***COLLEGE OF FINE ARTS (COFA)
REDEVELOPMENT, PADDINGTON***

MP 08_0104 (MOD 3)

Modification of Minister's Approval under section 75W
of the *Environmental Planning and Assessment Act*
1979

Figure 4: Building F northern façade as proposed to be modified. Major changes noted in red.

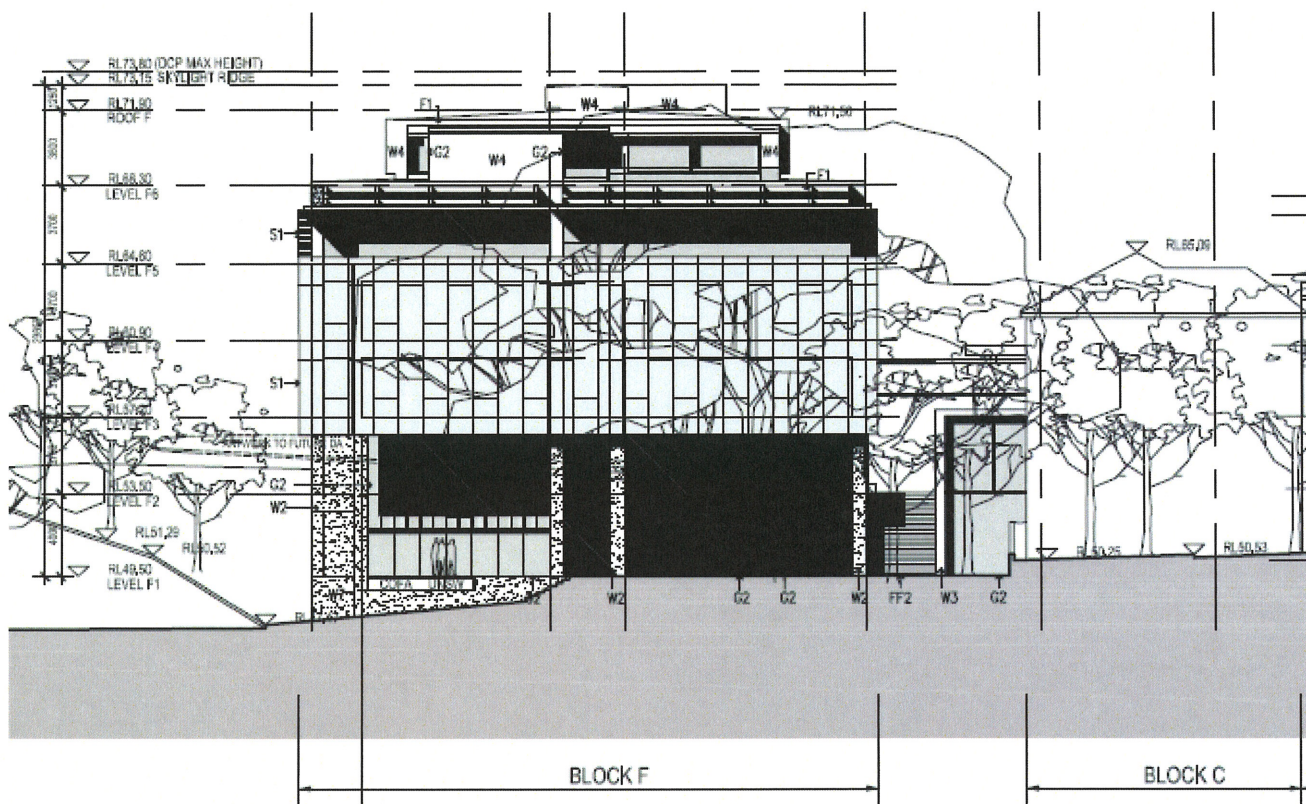
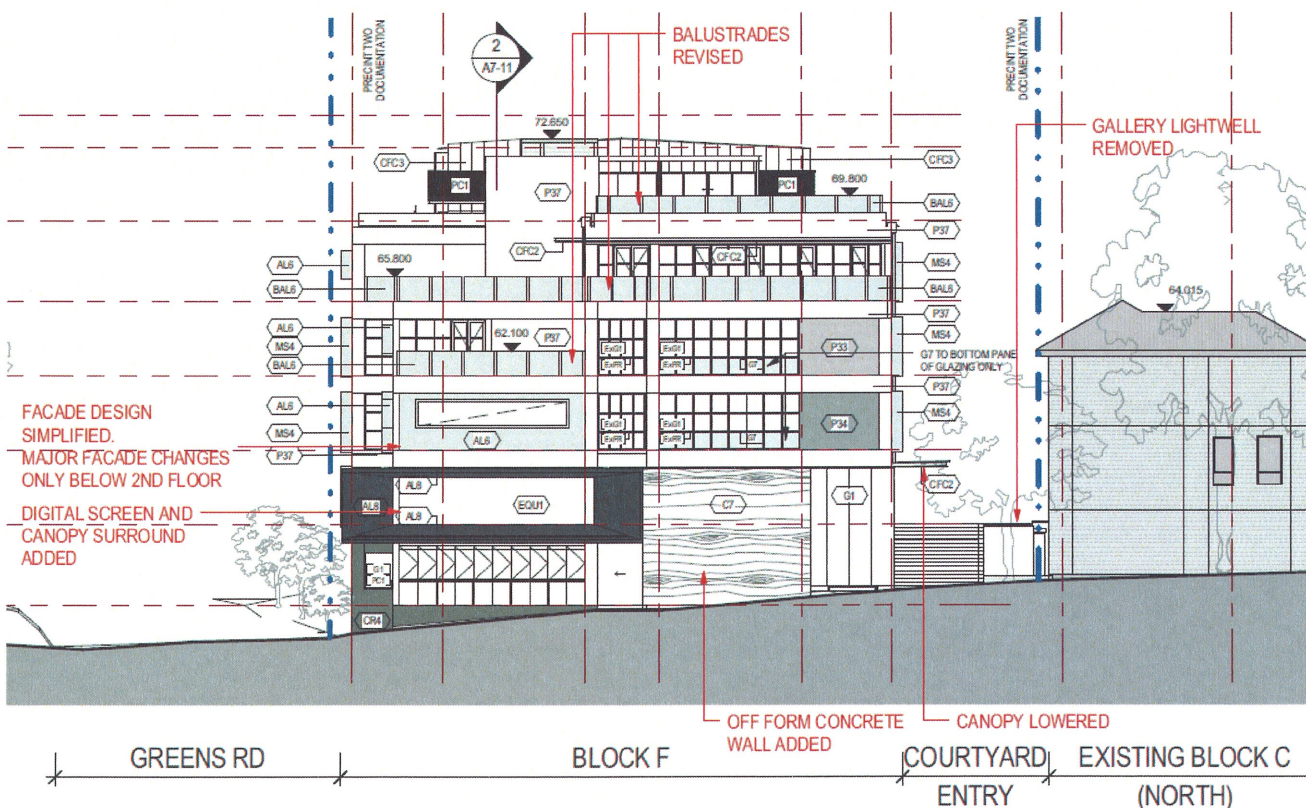
- the plans and images submitted with the application are insufficient to fully address the impact of the changes to the north facing elevation of Building F and how it addresses Napier and Oxford Streets;
- the opportunity to provide an iconic building that provides open and active ground floor uses to Napier Street will be lost; and

- the proposed wrap around digital screen is considered inappropriate for the site and location.

The digital screen proposed for the north eastern corner of the building presents a new element to the development. It is illustrated in Figure 4 above and on the title page of this report. The Proponent has outlined that the screen will be used to showcase art, design and media works associated with the CoFA and that it will not be used for the purpose of commercial advertising content. The Proponent proposes hours of operation of 8am -10pm, Monday to Saturday and 9am - 9pm on Sunday.

The proposed modification involves various changes to the built form and façade of Building F which are generally illustrated in Figures 3 & 4. These figures indicate that the modification proposes no changes to the building bulk and it remains generally in accordance with the permissible envelope as prescribed in the site specific DCP, as previously approved. It is proposed to modify the form of the northern end of the approved building at the upper levels with the introduction of open terraces in place of the sheer vertical façade originally approved, creating a stepped building form. The Department considers this modification to be acceptable as it will reduce the visual bulk of the building by setting back sections of the upper levels and will also add visual interest to this part of the site.

The Department notes that the canopy at the north east corner slightly overhangs the splayed corner boundary. This is considered acceptable as it is in-keeping with shop front design character in the area and also reinforces the corner element of the building.

The part of the Napier Street frontage occupied by the entry foyer façade further to the west of the café space is however proposed to be provided with a visually solid concrete finish in place of the approved glazing. The Department considers this visually solid element is acceptable as it only forms a small portion of the Napier Street frontage. Further, the foyer space as approved does not provide an activated street front to Napier Street. The Department considers this aspect of the proposed modification to be acceptable as the approved café will maintain an active street front for the building.

The proposal seeks approval for a redesigned entry to the internal courtyard via Napier Street, between Building F and Building C (see Figure 4 above). This modification presents a more open entry to the site. The updated entry way reinforces the area as a major site entry and will have a positive effect on the site and surrounding locale. The amendments are supported.

On 21 July 2011, Council advised the Department that after having reviewed the additional information submitted by the Proponent, it supports the proposed modifications.

Noting the above points and the assessment of the SEPP 64 criteria, the Department considers that the proposed screen meets the aims and objectives of SEPP 64 and is appropriate for the site and locality, subject to conditions relating to the hours of use and content of the screen.

The Department has reviewed the proposed façade treatment and considers it to be acceptable noting that it will maintain visual interest, modulate the building form and will maintain the design integrity of the approved building and the aesthetic of the locality. The Department considers that this modification satisfies the requirements of condition (9) of the approval. As such it is recommended that this condition be modified as requested which requires any further changes to the submitted materials and finishes to be approved by the Director General.
